**Product Update: Front Balancer Shaft Oil Seal**

(Supersedes 00-073, dated November 2000)

The front balancer shaft oil seal may slowly come out of the oil pump housing. If it comes out completely, the oil can be pumped out of the engine rapidly without warning, causing serious engine damage if you continue to drive.

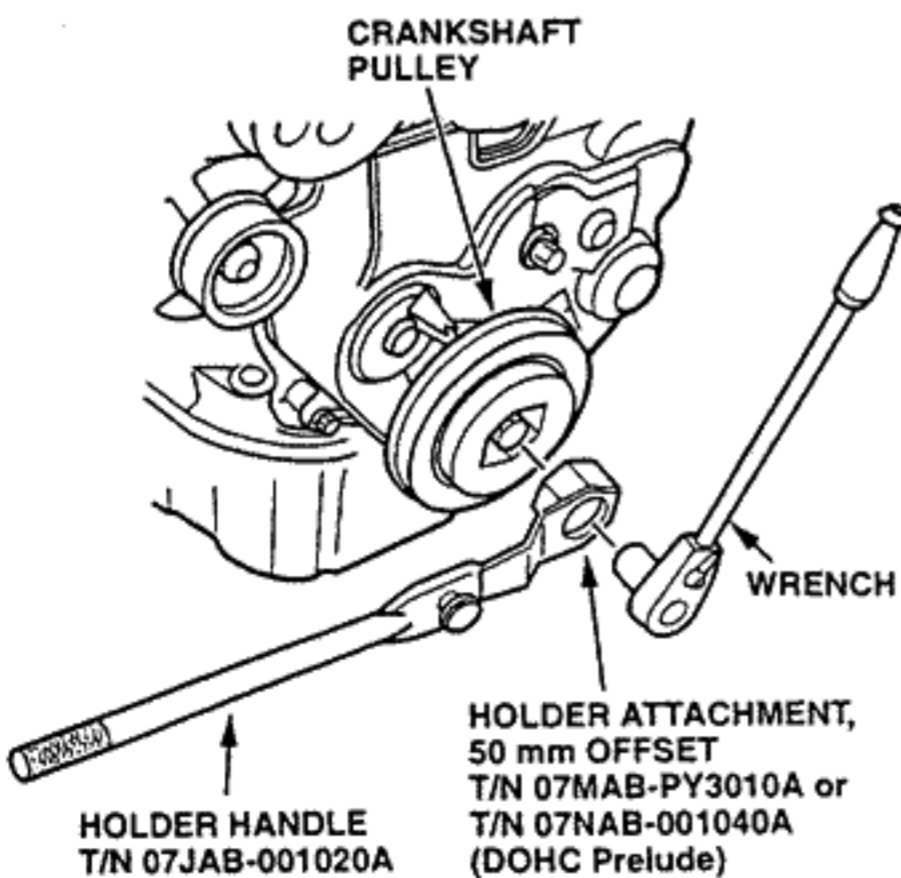
4. Loosen the mounting hardware for the power steering pump and the alternator. Then loosen the adjusting bolts 20 turns.
5. Remove the power steering pump belt and the alternator belt.
6. *DOHC Prelude only:* Remove the power steering reservoir and the power steering pump, and set them aside. Do *not* disconnect any power steering fluid lines.
7. Remove the dipstick and the dipstick tube. Make sure you cover the hole to keep debris out of the oil pan.

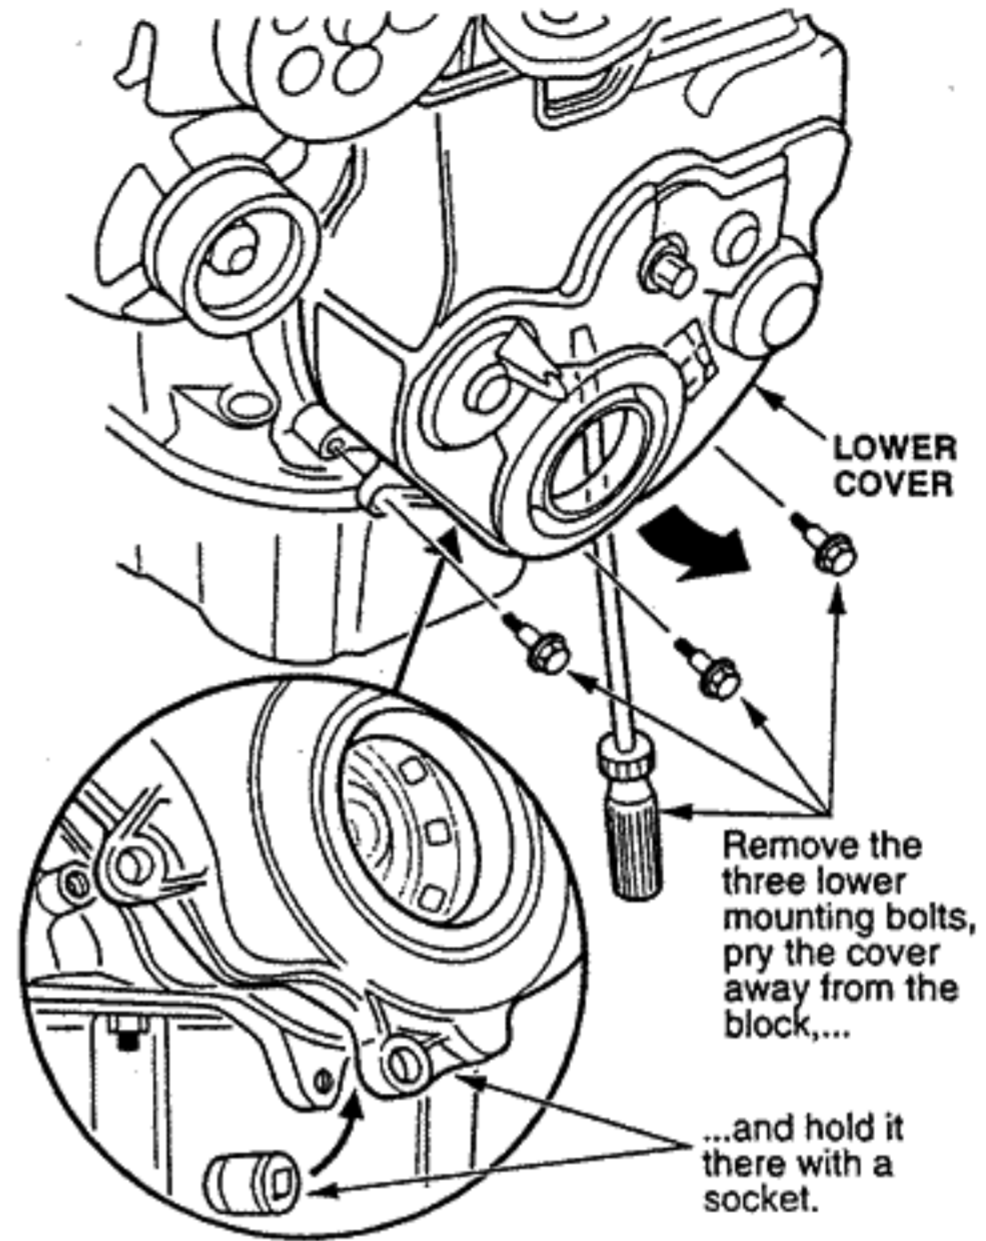
8. Raise the vehicle, and remove the left front wheel.
9. Remove the mounting bolts from the driver's side half of the splash shield. Pull back the splash shield, and secure it so you can access the crankshaft pulley.
10. Use the special tools and a wrench to remove the crankshaft pulley bolt, then remove the pulley.

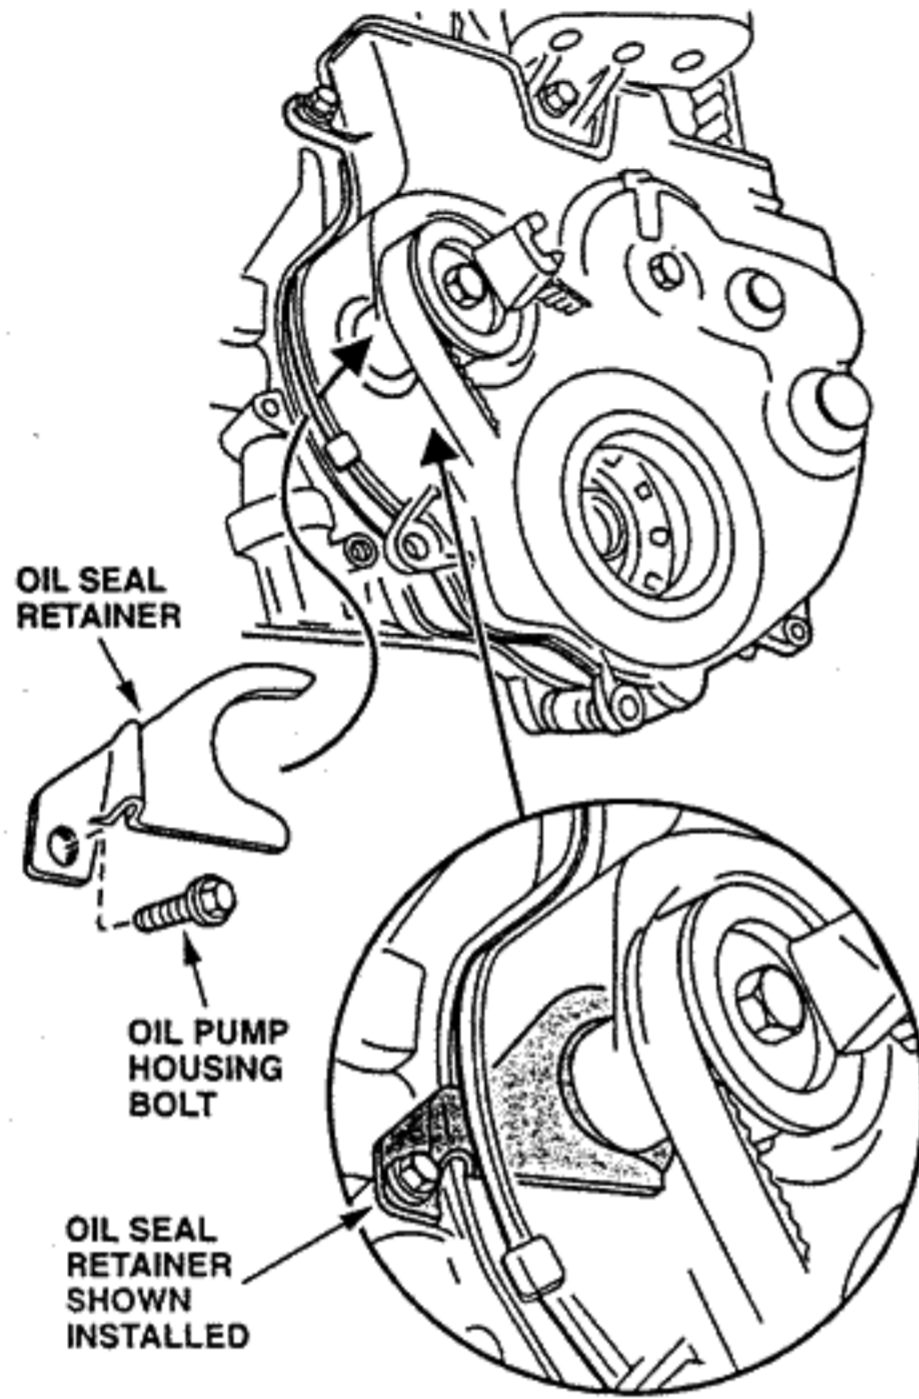
11. Remove the three mounting bolts from the lower cover. Pry the bottom of the cover away from the block about 25 mm, and use a socket or similar tool to hold it there.
